GROUP	MODEL
ELE	2024-2025MY EV9 (MV1, MV1a)
NUMBER	DATE
369	January 2025

TECHNICAL SERVICE BULLETIN

SERVICE ACTION: REAR MOTOR CONTROL UNIT SOFTWARE UPGRADE (SA601)

SERVICE ACTION: REAR MCU SOFTWARE UPGRADE (SA601)**ROM ID Information Table:****Upgrade Event #809 (MV1) or #810 (MV1a)****ⓘ IMPORTANT**

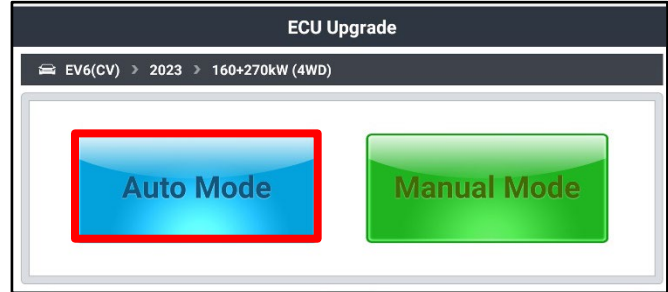
It is recommended to ALWAYS check the Electronic Parts Catalog (EPC) to locate the ECU Part Number respective to Auto/Manual Mode ROM IDs. DO NOT reference the parts label affixed to the ECU.

To verify the vehicle is affected, be sure to check the Calibration Identification of the vehicle's ECM ROM ID and reference the Information Table as necessary.

MY	Model	System	IMMO	ECU P/No.	ROM ID	
					Previous	New
2024-2025	EV9 (MV1)	MCU_R	Yes	36601 1XHNO	EMVDE23NERS7 010 EMVDE24NERS8 010	EMVDE24NERS9 010
2025	EV9 (MV1a)			36601 1XHN1	EMVAE24NERS0 010	EMVAE24NERS1 010
